Access Compliance Report Public Rights-of-Way (Curb Ramps)

Main Street: DEBORAH_DR Cross Street: WOODLAWN_AVE Location: N

ADA ID: RPRK220107132536 Ramp Type: Type 1 - Perpendicular Diagonal Initial Pass/Fail: Pass Overall Compliance: No Severity Score: 0

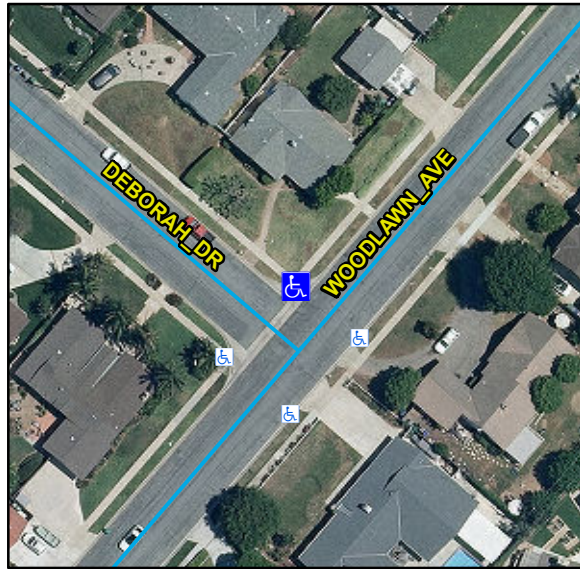
Compliance	Description	Data	Compliance	Description	Data
N/A	Ramp Length (in)	64	N/A	Flare Type LT	
Yes	Ramp Width (in)	48			Sloped
Yes	Ramp Run Slope (%)	7.8	Yes	Flare Slope LT (%)	6.2
Yes	Ramp Cross Slope (%)	0.4	N/A	Flare Traversable LT	Yes
N/A	Landing Present	Yes	N/A	Flare Type RT	
N/A	Landing Length (in)	49			Sloped
Yes	Landing Width (in)	48	Yes	Flare Slope RT (%)	6.1
Yes	Landing Run Slope (%)	1.3	N/A	Flare Traversable RT	Yes
Yes	Landing Cross Slope (%)	1.2	Yes	DWS Provided	Yes
N/A	Landing Movement Obstructed?	Yes	Yes	DWS Contrast	Yes
	Landing Movement Type	Curb	Yes	DWS Length (in)	36
N/A	Landing Shared	No	Yes	DWS Full Width	Yes
N/A	Clear Space	Yes	Yes	DWS Offset Left (in)	0
N/A	Clear Space To Crosswalk (in)	48	Yes	DWS Offset Right (in)	N/A
N/A	Marked Crosswalk 1	No	N/A	Marked Crosswalk 2	No
	Crossing 1 Direction	SW		Crossing 2 Direction	SE
	Marked Crosswalk 1 Width (in)	N/A		Marked Crosswalk 2 Width (in)	N/A

Remove & Replace Landing.
